DOC21/806692-7

**EPA Advice on Submissions Report
Mount Pleasant Optimisation Project – SSD 10418**

Attachment A – Air Quality Impact Assessment

Graph 1 – Timeseries showing the effect of implementing reactive measures at Receiver 112

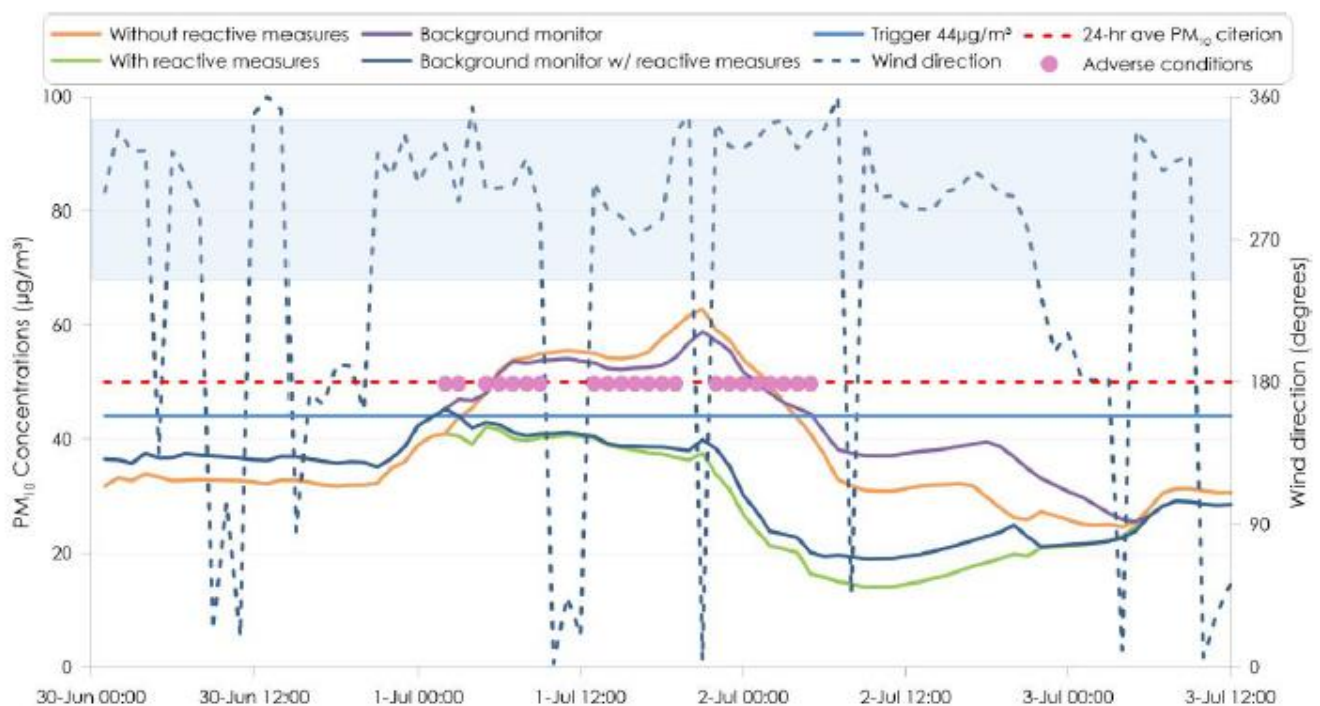
The EPA previously recommended that this issue had not been adequately addressed.

The EPA recommended that the proponent identified the specific triggers and specific actions that are modelled and therefore proposed to be used to manage particulate emissions and impacts at the affected receptors, both for Muswellbrook and isolated receptors, to demonstrate they will be able to manage the particulate emissions and impacts.

The Supplementary Information (September 2021) has improved the presentation of the data (Graph 1) to assist EPA's interpretation of the analysis. The analysis was provided for the sensitive receptor while the monitoring data (now included) is where the trigger level applies.

The Supplementary Information (September 2021) clarifies that the revised analysis applies the reactive measures (shutting down activities in the pit and overburden areas, while the CHPP and wind erosion emission continue) when the EPL trigger levels for Muswellbrook NW monitor and the trigger levels in the Mount Pleasant AQMP occur and no additional, lower or alternate trigger levels have been applied.

The EPA has determined this matter has been adequately addressed, and provided the recommended condition of approval (above) in relation to this matter.
